Item LPP01 - REPORTS - 1/11/2023

ADDRESS/WARD: 21 Cowdroy Avenue, Cammeray (C)

APPLICATION No: DA 38/23

PROPOSAL: Demolition of a dwelling house and construction of a new dwelling house.

Figure 12. Section diagram looking west, with the areas above 8.5m shown by the red line.

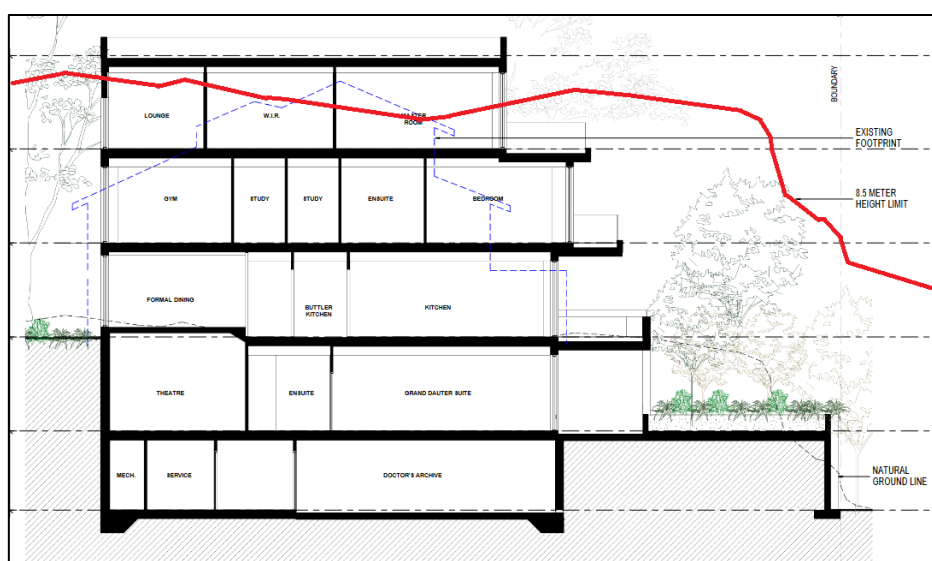
Due to the steep natural fall of the site, the majority of the roof and top Level 2 is above the 8.5m high limit at 10.94m (2.44m or 28.7%). Consequently, the proposed changes within Level 2 involve a variation of the Development Standard in clause 4.3 in NSLEP 2013 (see discussion below).

Figure 24. The outlook from the rear common garden.

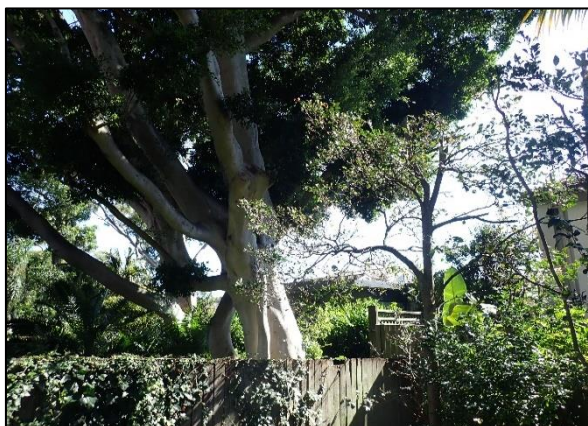
Common Garden – The common garden would retain the majority of its outlook to sky the north but would likely lose some sky due to the new roof level of the development. This loss will be created through the Level 2 addition of the subject site. Nevertheless, this overall view and general outlook will be retained by the proposal.

Overall, the view impacts to these properties are assessed as minor. Refer to **Figures 23-24** above.
